proposed alterations to  
No.7 main road, Hockley, essex. ss5 2rn  
for stibbards funeral directors

plans  
town planning application

date drwn. 03-12-09	scale 1:100 1:50 - 1:500	t.m.f. designs 4 sairard gardens eastwood leigh-on-sea essex. ss9 5aj tel / fax 01702-521009
dwg. no. mr-766	revision A

SITE/ LOCATION PLAN

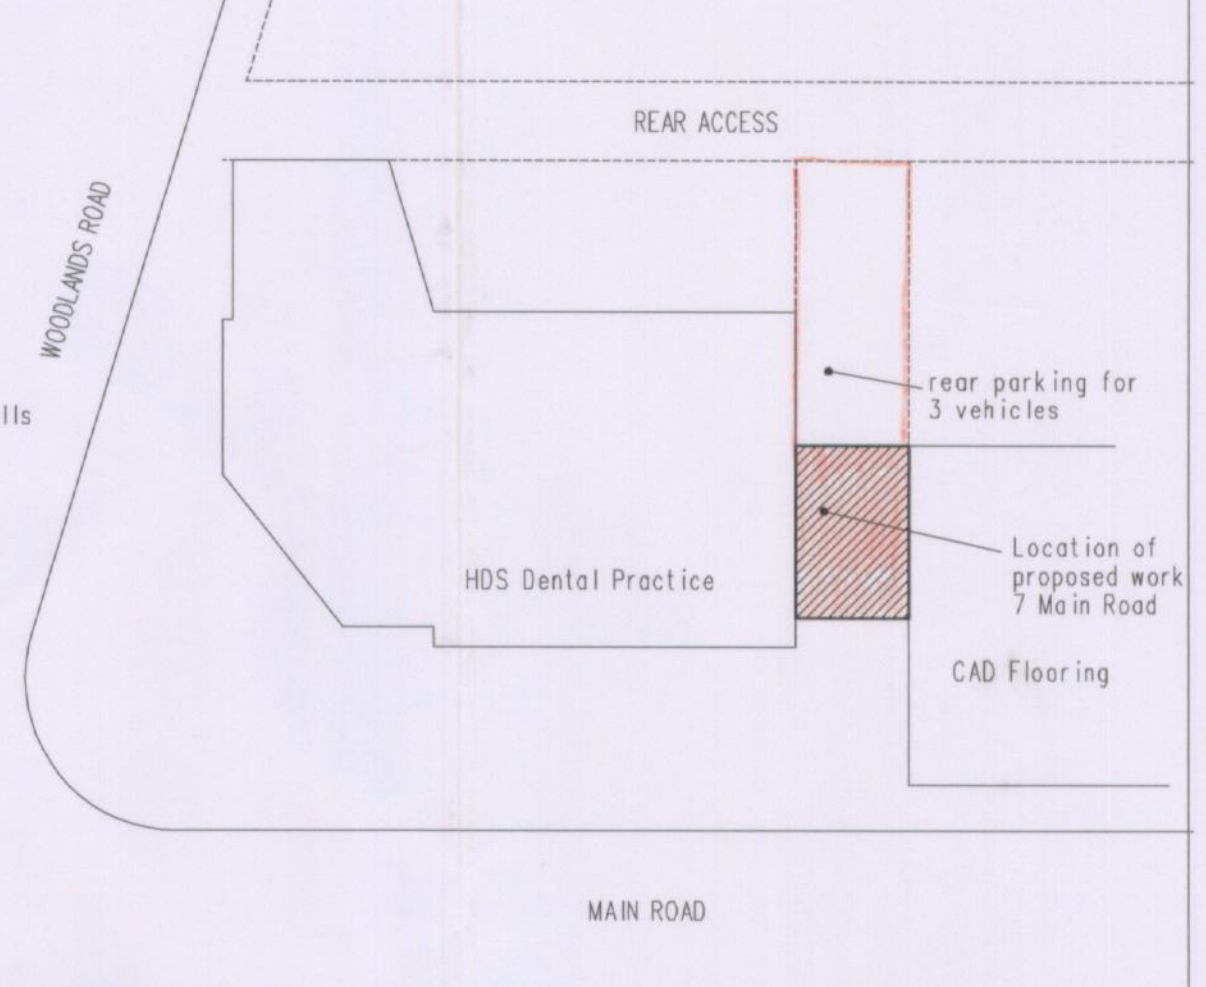
no.	date	
A	25-01-10	Revised to accord with LA TCP request 19th Jan 10/00006/COU 2/Exist elevations + new front elevation added on dwg No. mr-779 See note 2 3/External/Internal levels confirmed as exist-no change 4/Note 3 added re embalming 5/Scale of site plan revised 10/00007/ADV 1/Construction of sign noted and lettering clarified. Existing retained sign noted as new and finish noted 2/Scale site plan revised
